Technical Bulletin

TB 0277 – Fibreglass Cubicle Securing Improvement

To outline fibreglass cubicle security improvements and retrofit options for existing substations where required.

Figure 1: Design drawings for new Striker Plate design retrofit to current cubicle fibreglass design

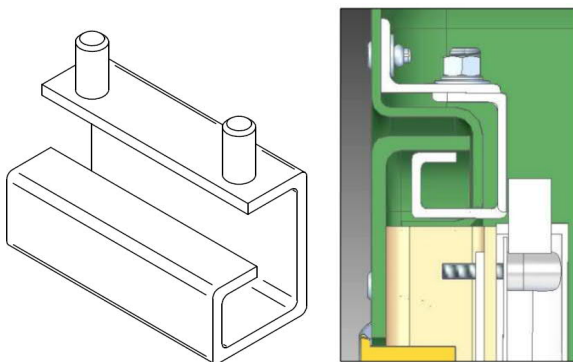
A new striker plate shown in Figure 1 has been deployed on all new fibreglass padmount substations since early 2018. The striker plate reduces the movement of the door over time. The striker plate is available as an inventory item as indicated in Table 1 and can be retrospectively installed in high risk areas.
